Rockwell service letter

Service Letter No. SL-AG-78

Revision No. 1

COLLECTOR RING REPLACEMENT

Figure 1.

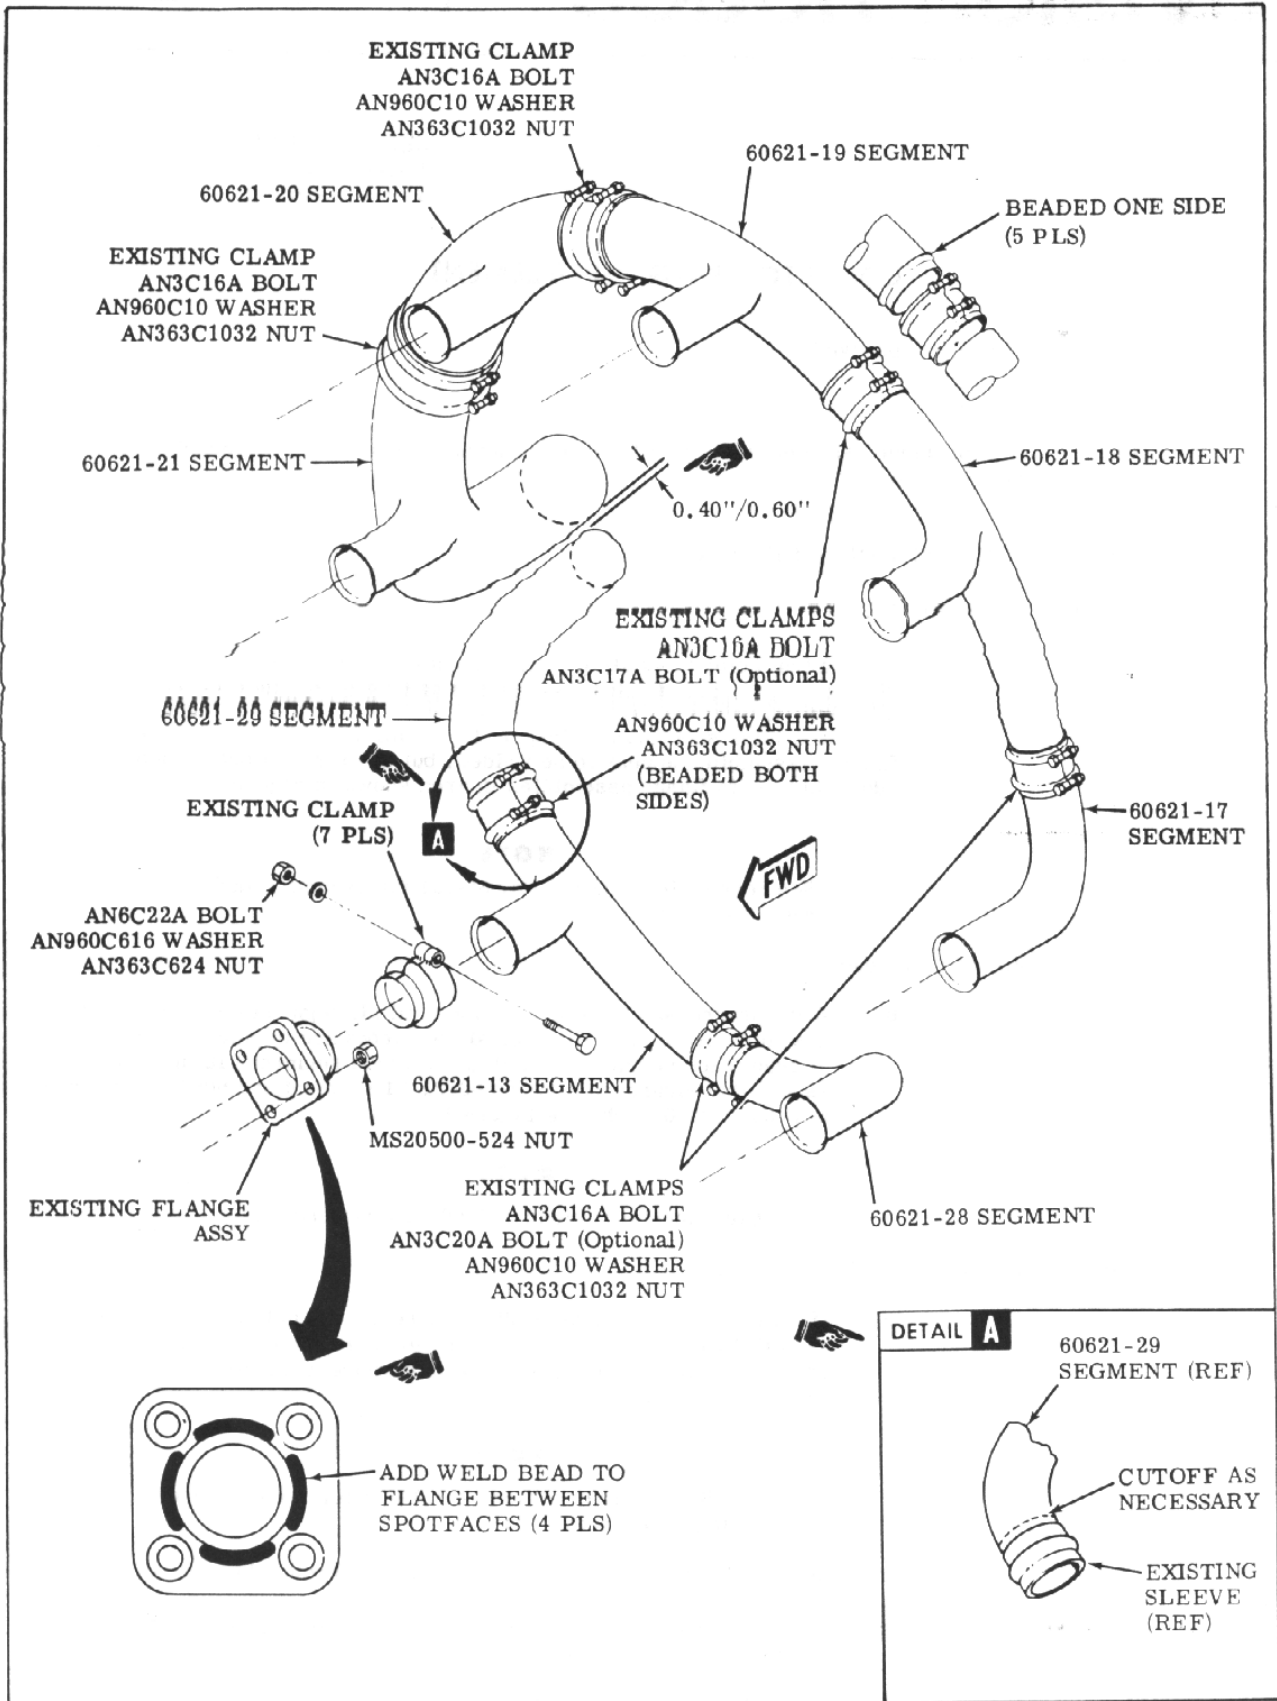
Add: View of flange assembly to figure 1 showing area to be welded. See sheet 3 of this revision.

- 4 Assure that hole in existing flange assemblies are spot faced 0.80 inch diameter on center of bolt hole. Flange to be a minimum thickness of 0.25 inch after spot facing. Inspect flange for weld attachment (some flange assemblies appear to be welded, but are not). If not welded, add weld bead to flange assemblies in area shown in figure 1.

- b. Work progressively around engine until all segments of collector ring assembly are in place. After all segments are in place and properly aligned (each segment must align with next segment within 0.040-inch), assure that clearance between 60621-21 segment and 60621-29 segment is 0.50 (± 0.10) inch (see Figure 1).

- c. If clearance is less than 0.40-inch, remove 60621-29 segment and rework by cutting segment off at sleeve. Remove sufficient material from segment provide adequate clearance and reweld segment to sleeve (see Figure 1).
